FIELD SERVICE ACTION		
To: For the attention of: Please copy to:	All Dealers/Importers The Service Manager The Dealer Principal The Parts Manager Aston Martin Technician(s)	Reference: FSA: 129
Model:	DB9	Issued: September 2005
VIN Range:	(--)0001 to (--)3811	
Subject:	Front Anti Roll Bar Bracket Fixings	Page: 1 of 3

FRONT ANTI-ROLL BAR BRACKET FIXINGS (X4)

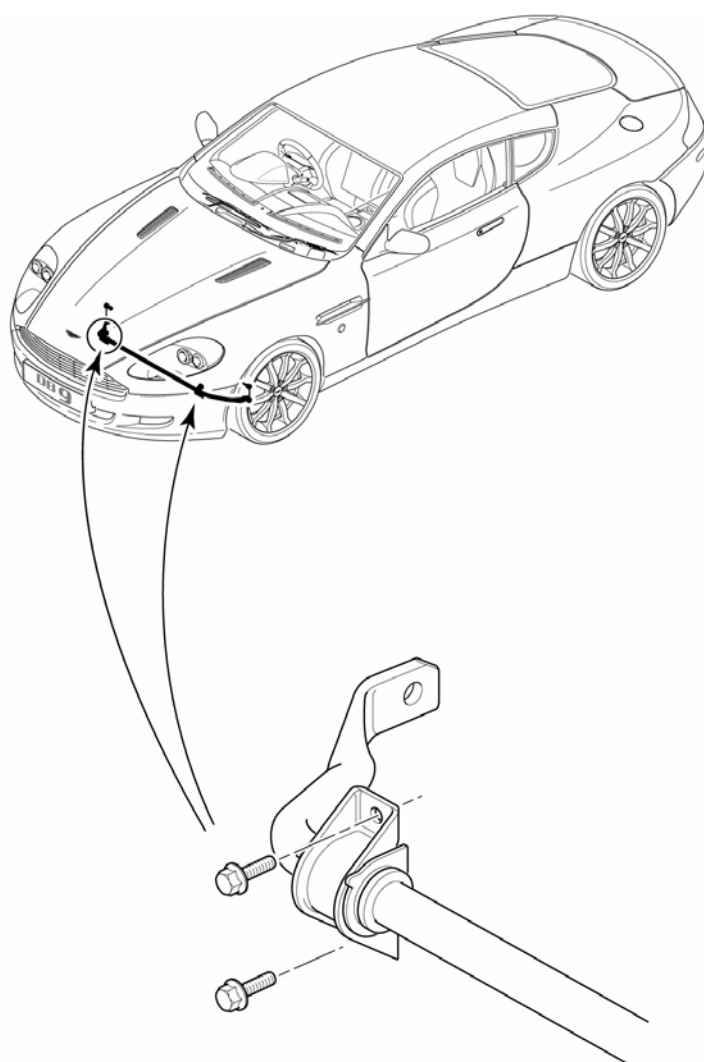
As a result of continuing Quality and Engineering investigations, a potential torque relaxation issue has been identified on the DB9 Front Anti Roll Bar Bracket fixings. To address this issue, please carry out the following workshop procedure.

- Ensure that the DB9 workshop vehicle protection kit is fitted
- Position the vehicle on a two-post wheel free ramp and raise the vehicle
- Remove the front undertray for access
- Locate the four Front Anti Roll Bar Bracket Fixings (M8 x 20 Flange Head Bolts, Part Number 700123) See the illustration overleaf
- Check and torque the fixings to 24Nm
- Refit the front undertray
